SUNDRY NOTICE

1. OGCC Operator Number: 66561 4. Contact Name: Chris Clark
2. Name of Operator: OXY USA, Inc., Attn: Glenda Jones
3. Address: P.O. Box 27757 City: Houston State: TX Zip: 77227-7757
5. API Number: 05-077-09268-00 OGCC Facility ID Number
6. Well/Facility Name: Hells Gulch 23-12A Fed. 7. Well/Facility Number: 23-12A
8. Location (Qtr/Qtr, Sec, Twp, Rng, Meridian): SWSW Section 23, T8S, R92W 6th P.M.
9. County: Mesa 10. Field Name: Alkali Creek
11. Federal, Indian or State Lease Number: COC 66918

OXY USA WTP
WELLHEAD
3D DRAWING

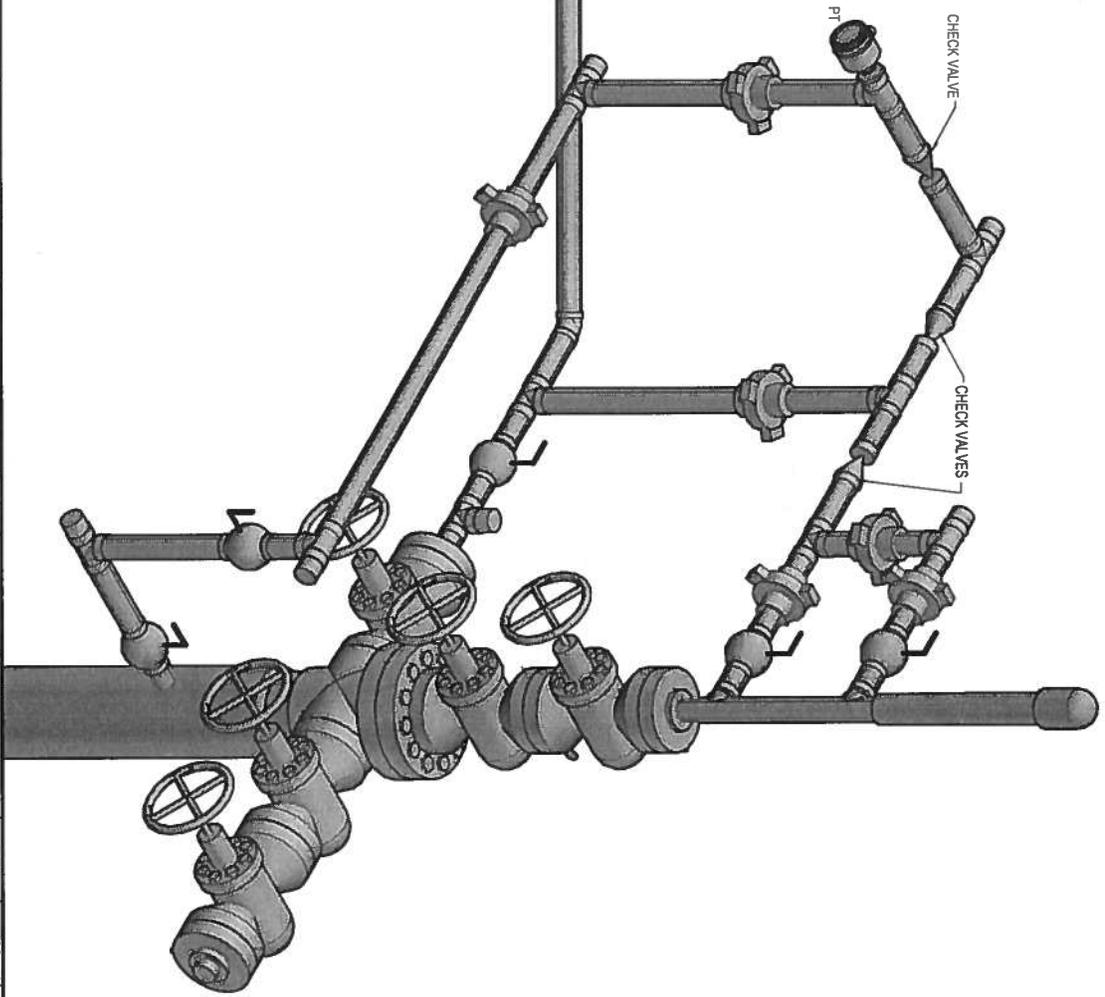
Attached is a 3D piping diagram showing our proposed piping modification. The line will be constructed of threaded schedule 80 pipe and equipped with two block valves, two check valves and a pressure transducer which will be integrated into our remote monitoring system. The gathering system at this location consistently runs less than 150 psi, and is generally running ~110-120psi. Keeping the bradenhead open and venting into this system will allow any excess pressure which might build in excess of 150psi to vent.

The pressure transducer on the bradenhead will be integrated into our ICONIX system which will allow for remote monitoring along with the ability to set alarms as warranted to assure that the bradenhead does not operate in a over pressured manner. If/when we experience extended upsets causing high line pressure our Lease Operators will manually set the valves to bleed any excess (<150psi) pressure to the product ion tank battery located on site.
